# FINAL DRAINAGE REPORT FOR SOLACE APARTMENTS

> November 25, 2020 Project No. 25174.00

PCD File No. PPR-20-047

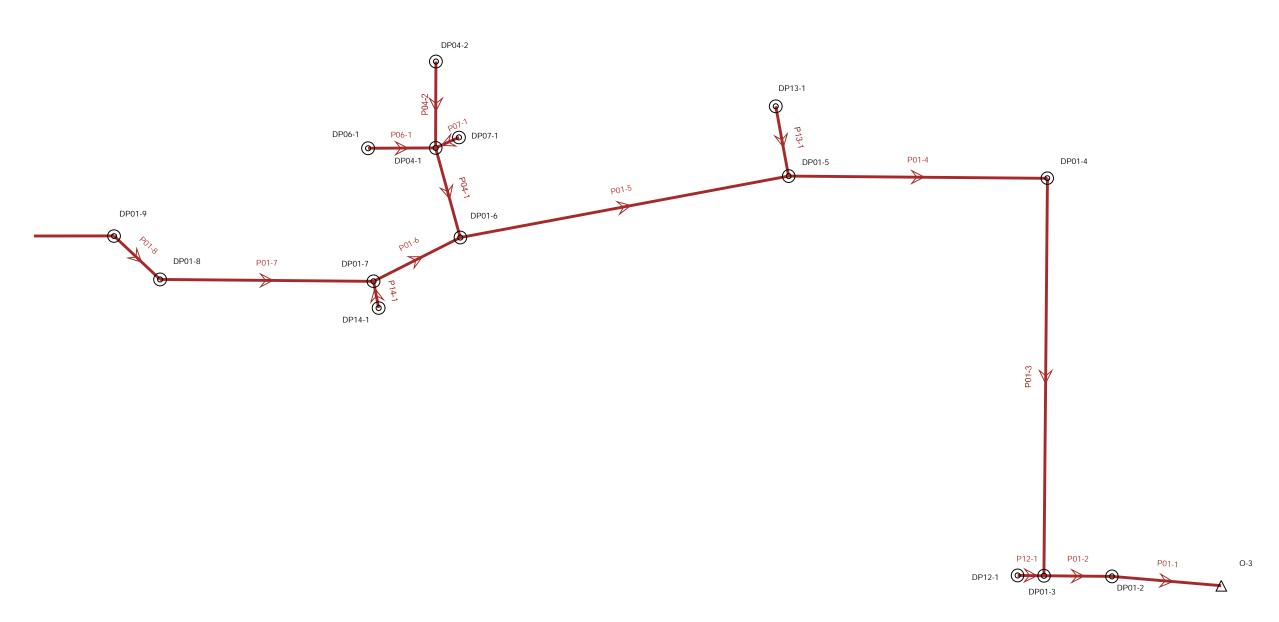
Please revise to include design point 16 and 17 to pipe summary sheets.

Please remove inconsistencies between drainage report and construction drawings regarding pipe slopes.

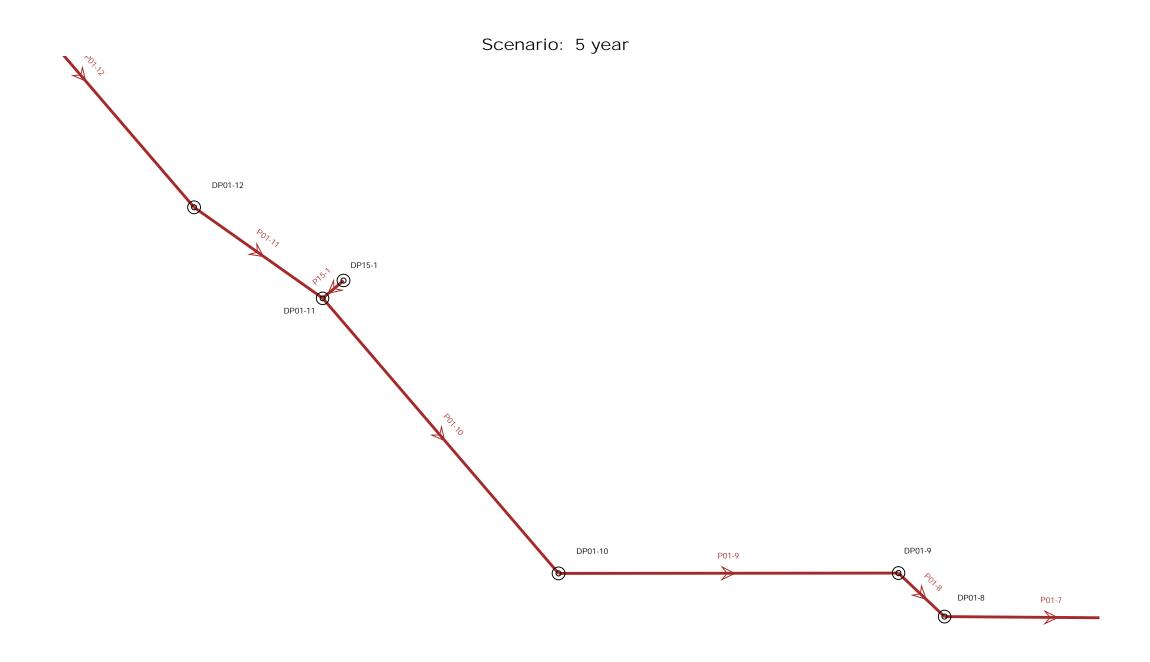
Please update to show velocity in pipe.

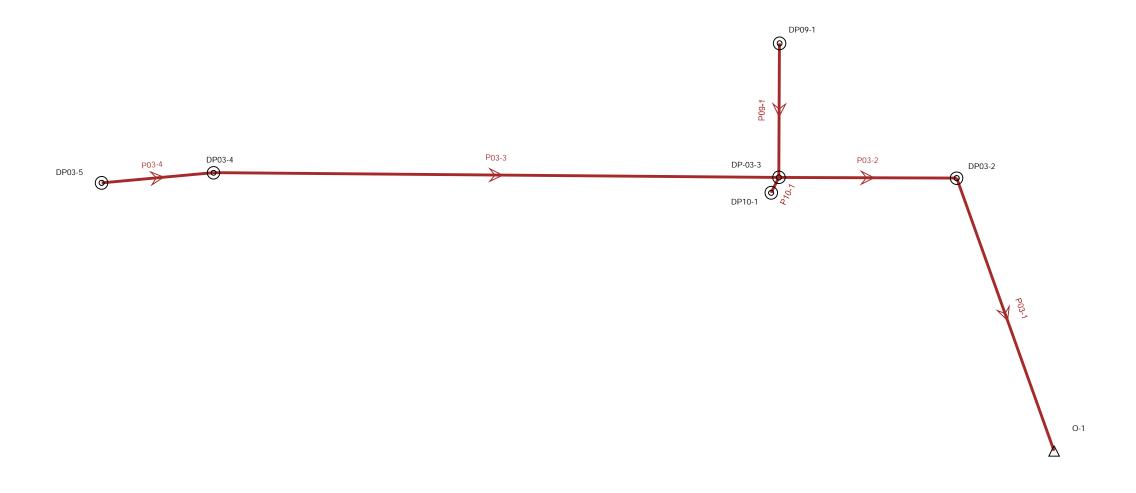
Please revise to include design point 16 and 17 to pipe summary sheets.

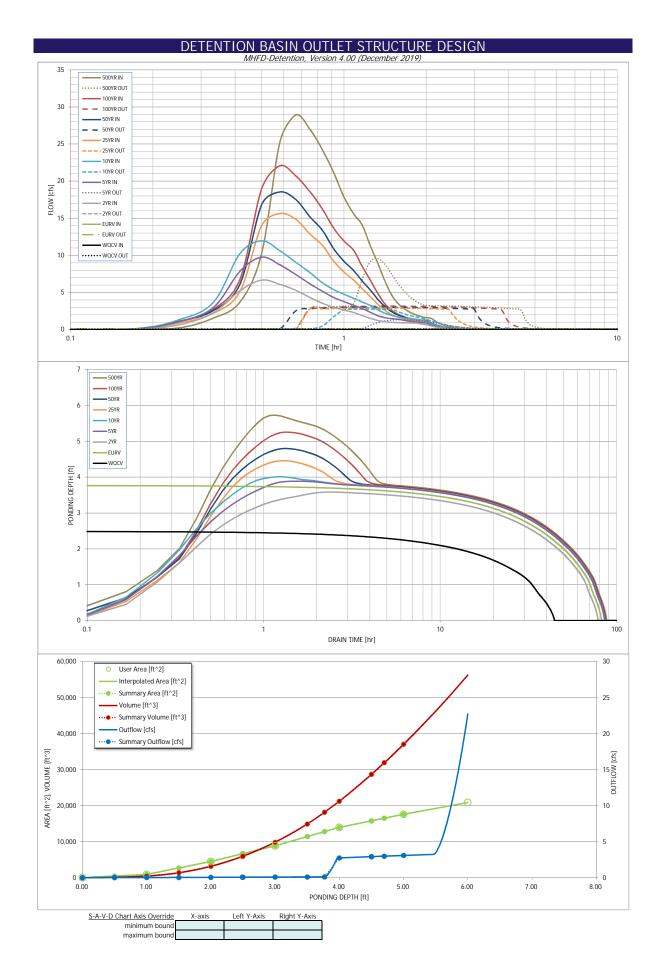
does not match the side slopes on the detail Please revise accordingly

This length does not match what is shown on the pond detail. Please revise accordingly.

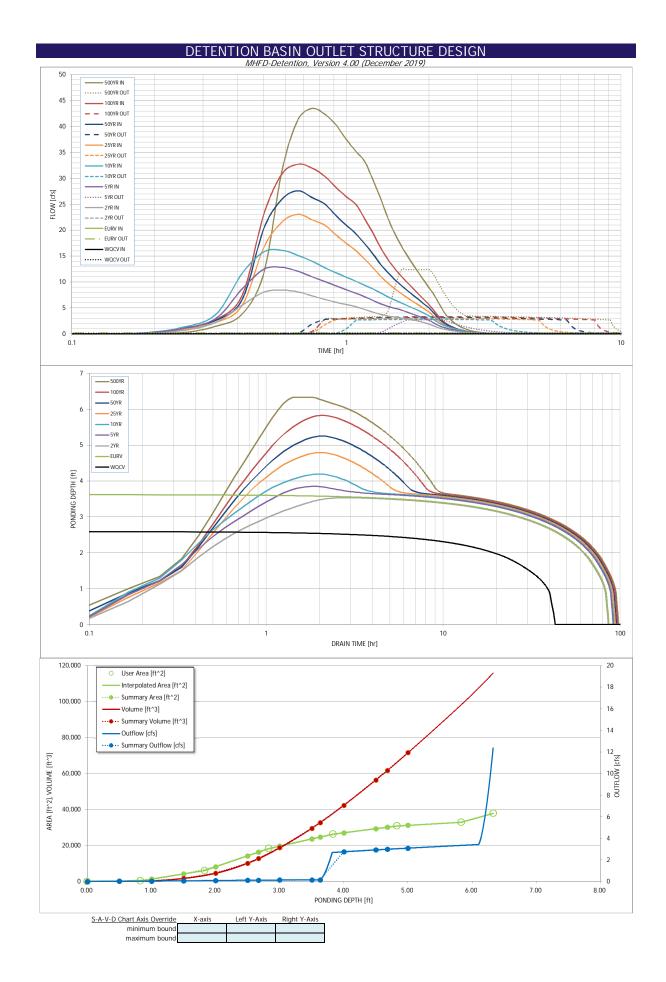
This length does not match what is shown on the pond detail. Revise accordingly.

This does not meet the drain time requirements indicated in senate bill 15-212. Please revise accordingly.
